MINUTES OF COMPULSORY BRIEFING SESSION MEETING FOR BID:

DWS03-0419 WTE

SUPPLY AND DELIVERY OF FINE AGGREGATE, COURSE AGGREGATE;
CRUSHER RUN AND RIP RAP TO THE DEPARTMENT OF WATER AND
SANITATION CLANWILLIAM DAM.

DATE : 14 MAY 2019

Quarry area layout and designated stockpile areas

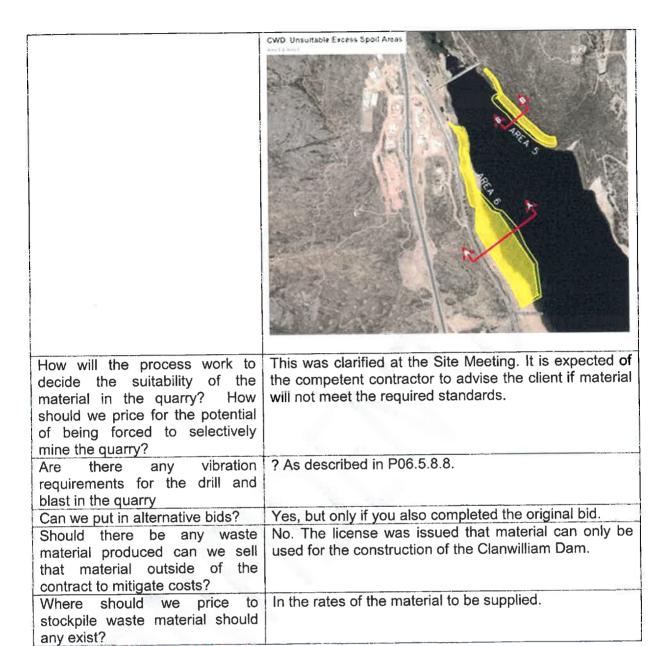
Is the plan for us to use one of the designated stockpile areas to set up the crushing plant? We would prefer that the crusher is erected next to the quarry.

If so which one is preferred?

Are there designated areas to store the overburden removed from the quarry area?

The only other area would be at Stockpile area 3. The use of this area would have to be motivated and it must also be noted that there are fruit trees directly next to the Stockpile Area 3. Any dust or other nuisance would be for the Contractors account.

Material can be spoiled inside the dam basin directly opposite the quarry. Indicated as Area 6 below.
